REQUEST FOR CEQA HEARING

RE: 2655 Broderick
Block 0955 Lot 002
Permit Application: 2013.09.12.6709
DR case No: 14.1497D
Permit Application: 2013.0912.6711
DR case No: 14.1498D

CEQA Categorical Exemption Determination by Mary Woods
December 5, 2014

Re: Planning Commission Hearing on 2655 Broderick
WJE No. 2009.4685.0

COTTON, SHIRES AND ASSOCIATES, INC. CONSULTING ENGINEERS AND GEOLOGISTS		
TEST PIT 1 2655 Broderick Street Geotechnical Investigation San Francisco, California		
GEO/ENG BY JN	SCALE 1"=1'	PROJECT NO. E5270
APPROVED BY POS	DATE JANUARY 2012	FIGURE NO. 2

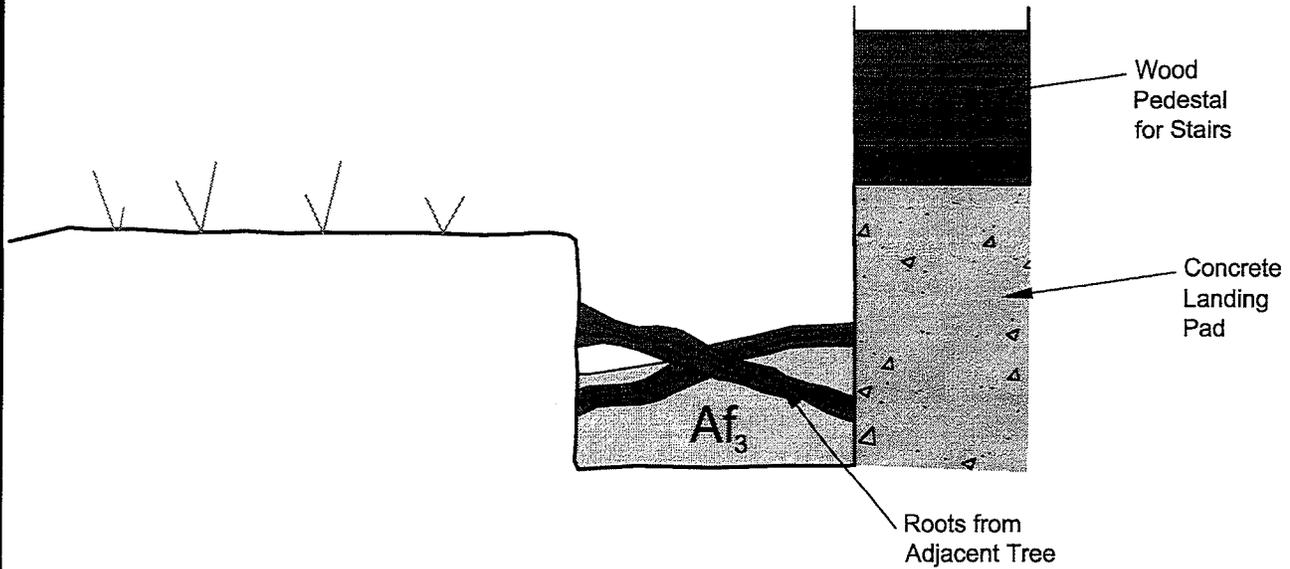
TP-1 (Figure 2) was located along the western end of the deck stairs landing. Due to abundant large tree roots, this test pit was terminated at a depth of about 1.3 feet. The concrete footing for the landing extended deeper than the test pit and the earth materials encountered were silty sandy artificial fill (designated Af3).

GEO/ENG BY JN	SCALE 1"=1'	PROJECT NO. E5270
APPROVED BY POS	DATE JANUARY 2012	FIGURE NO. 3

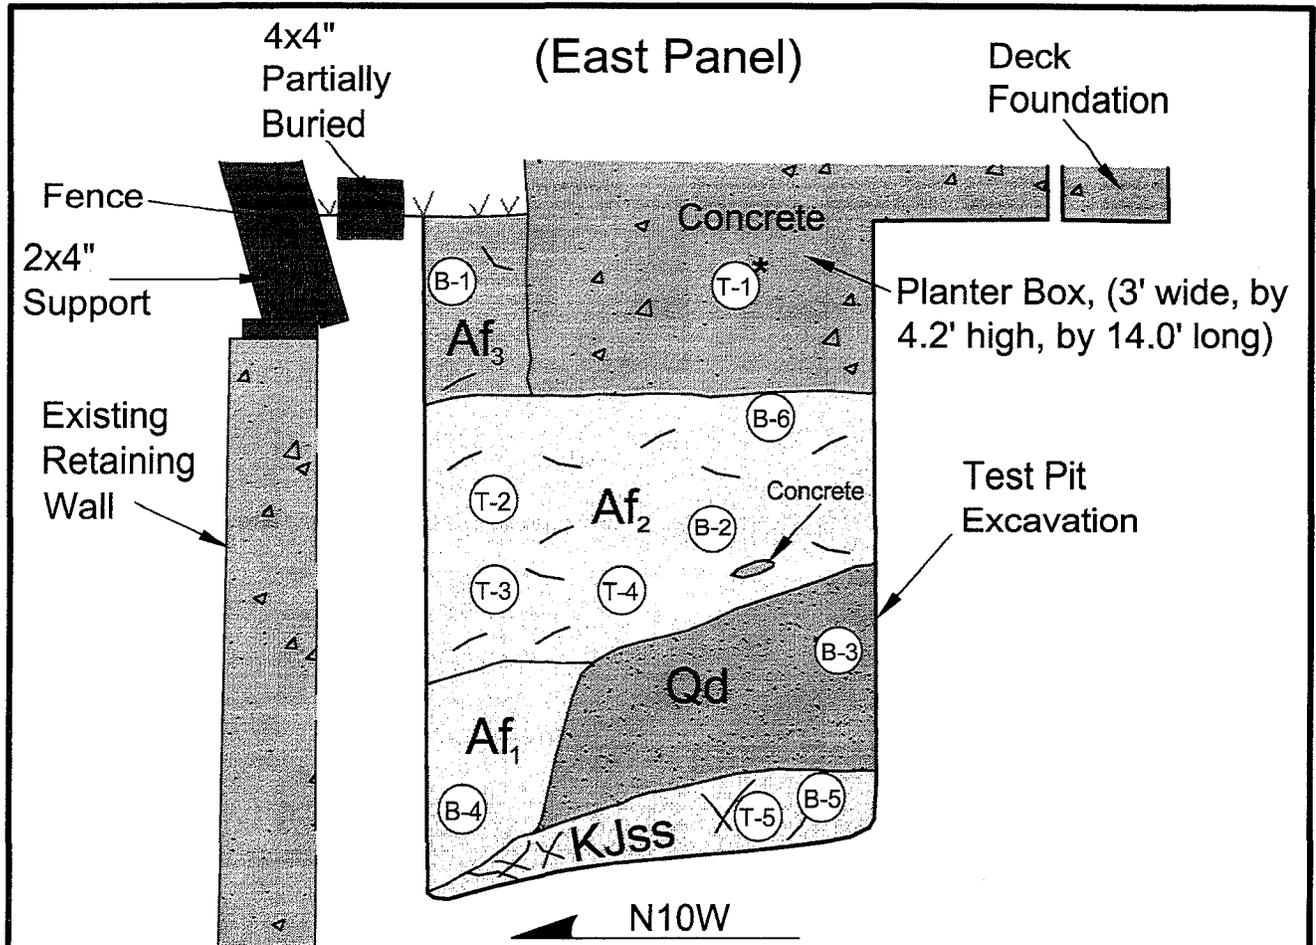
Test Pit TP-3 (Figure 3) was located at the western end of the concrete planter box and extended to a depth of about 3.9 feet. Bedrock (sandstone of the Franciscan Complex) was encountered at a depth of about 3.5 feet beneath the ground surface. We encountered three types of artificial fill (designated Af1, Af2 and Af3) in this test pit. Af1, the deepest artificial fill, consisted of silty sand with clay. This fill abutted and truncated Quaternary dune sand which was found above the bedrock with a thickness of about 1 foot. Above the Af3 and dune sand was Af2, artificial fill consisting of silty sand containing significant fines content. The footing for the planter box was founded in this fill material with additional artificial fill, Af1, placed on the retaining wall side of the planter box against the bottom of the wooden fence constructed on top of the retaining wall. The Af3 fill consisted of silty sand. Test pit

Planter Box - Based on the strength and distribution of earth materials beneath the planter box, most of the load from the box is transferred to the sandstone bedrock beneath the footing and any lateral pressure exerted on the existing retaining wall is minimal. Even neglecting soil cohesion, the lateral load from the planter box distributed to the retaining wall would only be on the order of 140 psf over the upper 3.5 feet of the retaining wall and nil below that due to the presence of the sandstone bedrock.

While we are of the opinion that the deck staircase footing and planter box represent minimal lateral loads to the retaining wall, for the reason discussed above (and for conservatism), we recommend that these structures be underpinned into the sandstone bedrock. There is approximately 1.7 feet thickness of artificial fill soil beneath the deck staircase footing and 2.2 to 2.5 feet thickness of artificial fill soil beneath the planter box until sandstone bedrock is encountered. We recommend that reinforced concrete underpins with haunches extending under and dowelled into (minimum 6 inches epoxied embedment) the existing footings be installed at minimum 6 feet edge to edge beneath these structures. Underpins should extend a minimum of 2 feet into the sandstone bedrock. All artificial fill should be removed between the planter box and the top of the retaining wall and underpins should be located at each end of the planter box adjacent to the retaining wall as well as midway along the planter box on the deck side. Underpins and haunches should be steel reinforced concrete with a minimum of 4 number 4 bars vertical in each underpin and horizontal in each haunch (with minimum 3 inches concrete cover over the steel). Concrete should have a minimum 28-day unconfined compressive strength of 3,000 psi. Shop drawings of all underpins and haunches should be provided by the contractor and approved by the engineer prior to construction. All excavations should be inspected by the engineer prior to pouring of concrete.
